ONTARIO ENERGY BOARD

A PROCEEDING TO DESIGNATE A
TRANSMITTER TO CARRY OUT DEVELOPMENT WORK
FOR THE EAST-WEST TIE LINE

INTERROGATORIES OF THE INDEPENDENT ELECTRICITY SYSTEM
OPERATOR ("IESO")

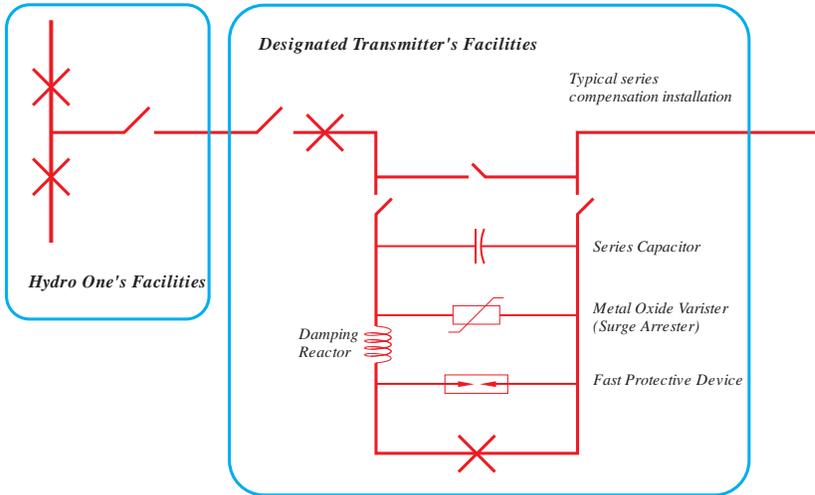
Subsequent to issuing the Feasibility Study, Hydro One informed the IESO that any reinforcement of the East-West Tie that involved an 'enhanced' connection would require special protective relaying and would need to be separately switched. This switching would be independent of the switching provided within the Hydro One transformer stations.

Therefore options that include the use of series compensation, or HVdc converters, would need to include separate breakers located in switchyards owned by the designated transmitter for the project.

1. With the Proposed Series Compensation Distributed Evenly between the Two Terminals of Each Line

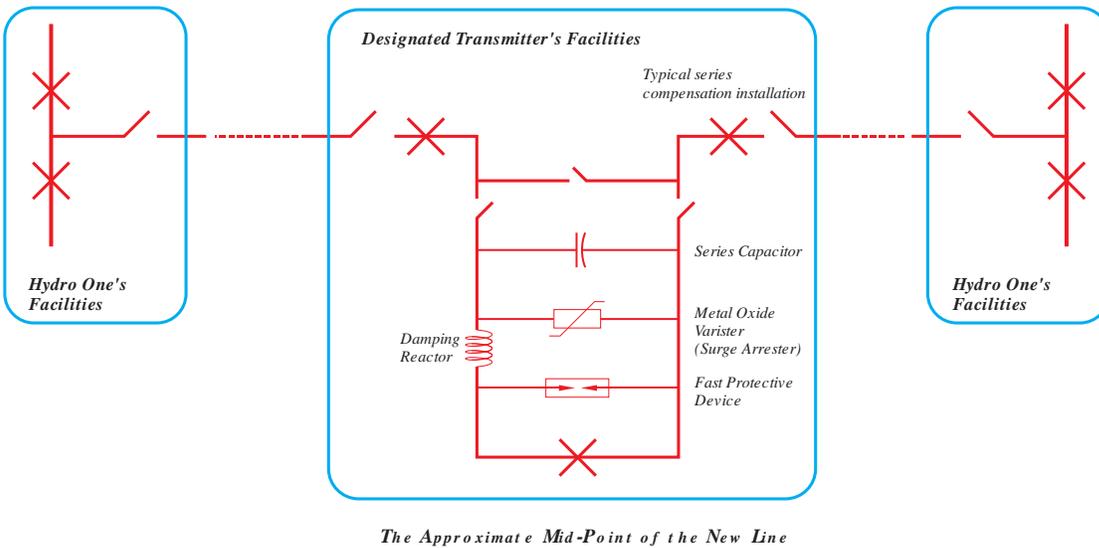
Series compensated projects would need to include land acquisition and site preparation for the separate switchyards with breakers and isolating and bypass switches, surge arresters, the series capacitors and associated structures, protective relaying and in particular, protections and facilities to protect the series capacitors, and any other associated equipment. The diagrams below are examples of the series compensation arrangement.

- (a) Please identify the terminal arrangements and associated facilities for your proposed series compensated lines, and please confirm the total cost of procuring and installing the series compensation facilities, including the facilities described above for each series-compensated line.
